- 21.** Address/Description: 424 CLUB DR
HDRC Case No.: 2024-288
Historic District Name: Monticello Park
Applicant: Christine Villarreal/TRIO INVESTMENT PARTNERS LLC
Request: Fenestration Modification | Modify the existing two front door entryways to one, double door entryway
City Council Dist.: 7

HISTORIC AND DESIGN REVIEW COMMISSION

HDRC CASE NO: 2024-288
ADDRESS: 424 CLUB DR
LEGAL DESCRIPTION: NCB 7013 BLK LOT W 60 FT OF 4
ZONING: RM-4, H
CITY COUNCIL DIST.: 7
DISTRICT: Monticello Park Historic District
APPLICANT: Christine Villarreal/TRIO INVESTMENT PARTNERS LLC
OWNER: TRIO INVESTMENT PARTNERS LLC
TYPE OF WORK: Fenestration Modification | Modify the existing two front door entryways to one, double door entryway
APPLICATION RECEIVED: August 02, 2024
60-DAY REVIEW: October 1, 2024
CASE MANAGER: Claudia Espinosa

The applicant is requesting a Certificate of Appropriateness for approval to modify the existing front door configuration from two, separate, single leaf doors to a double door.

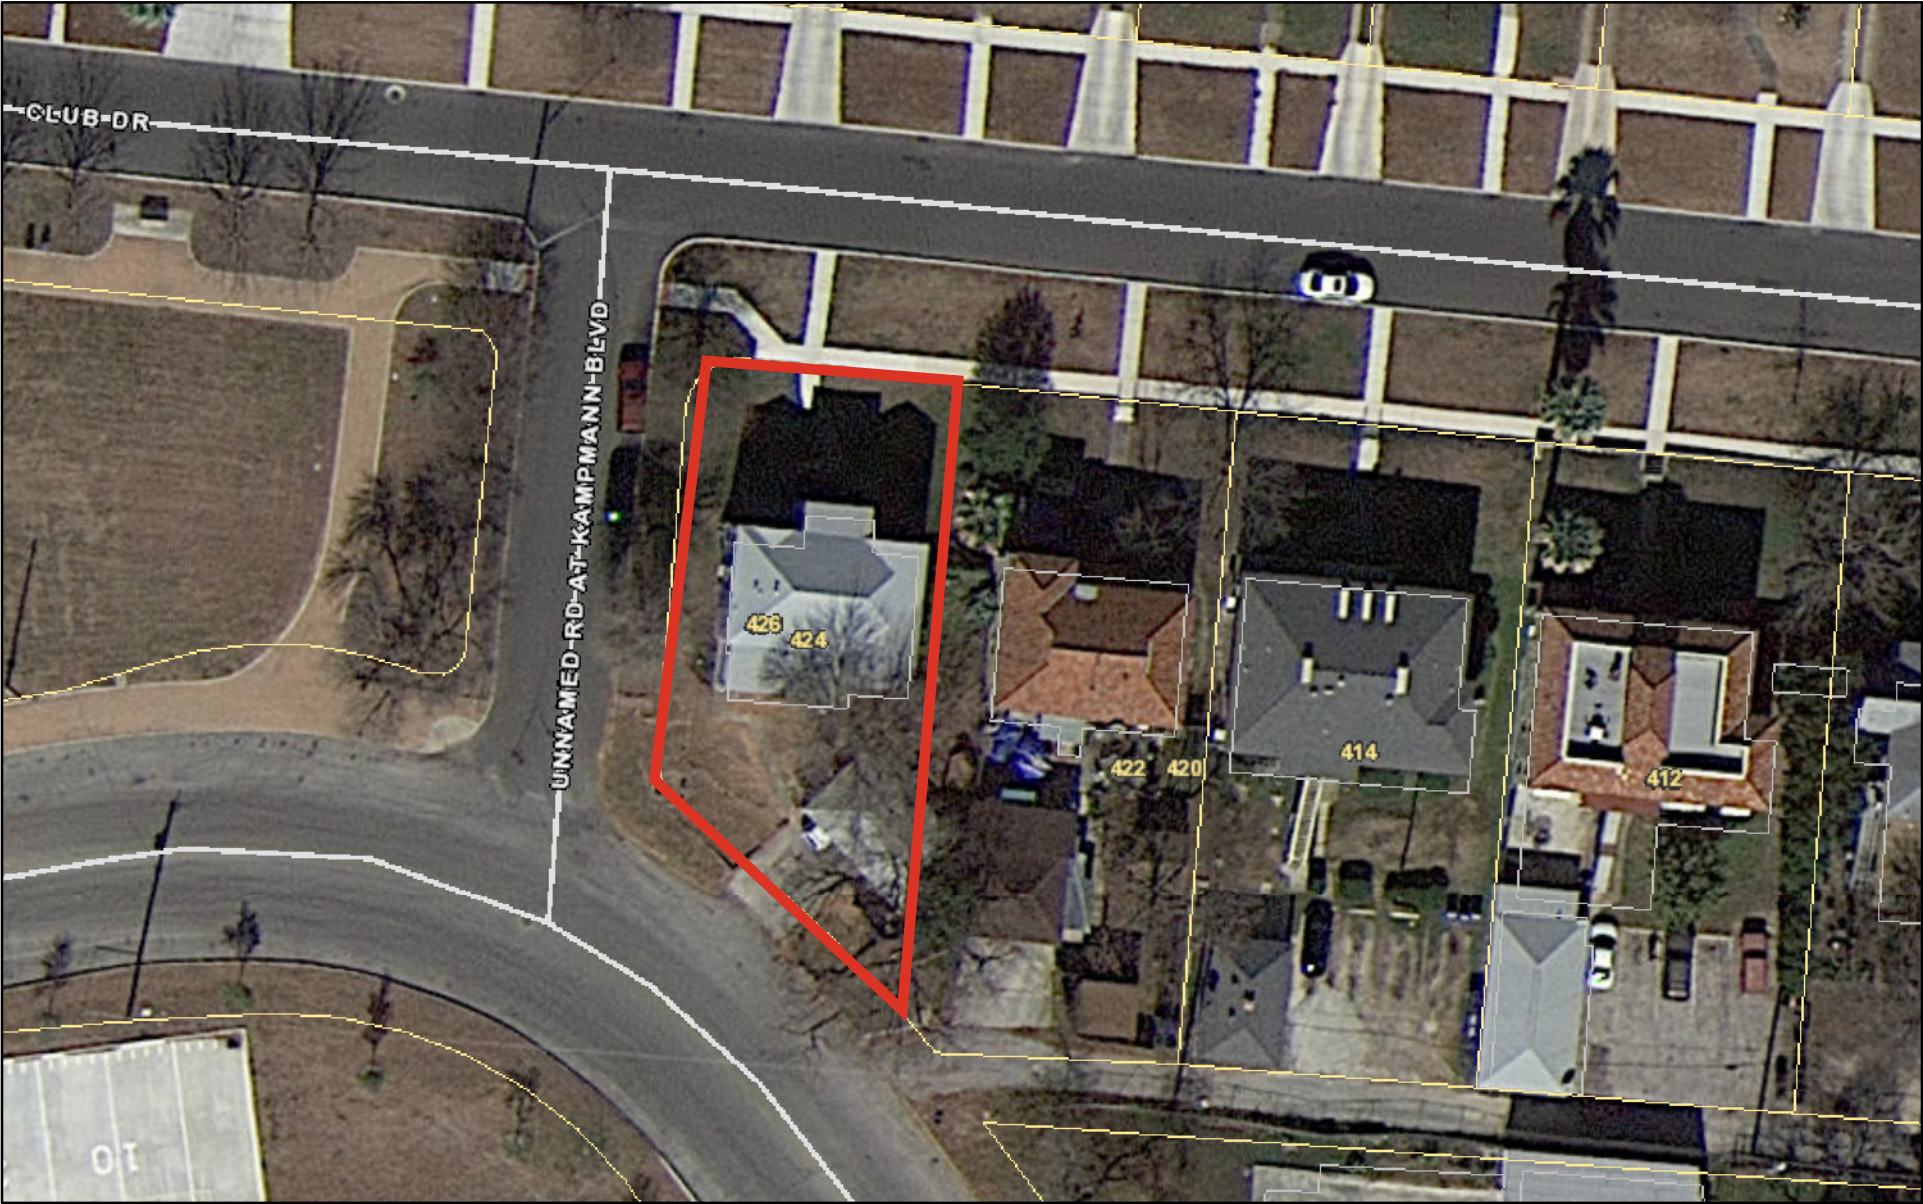
- c. FENESTRATION MODIFICATION (FRONT DOORS) – The applicant requests approval to the existing front door entrances of the primary structure and replace them with a double door entryway. The Guidelines for Exterior Maintenance and Alterations 6.A.i and ii state that historic doors and windows should be preserved. Staff finds the proposed door removal does not conform to guidelines.

Staff does not recommend approval of the modification of the existing front door configuration based on finding b.
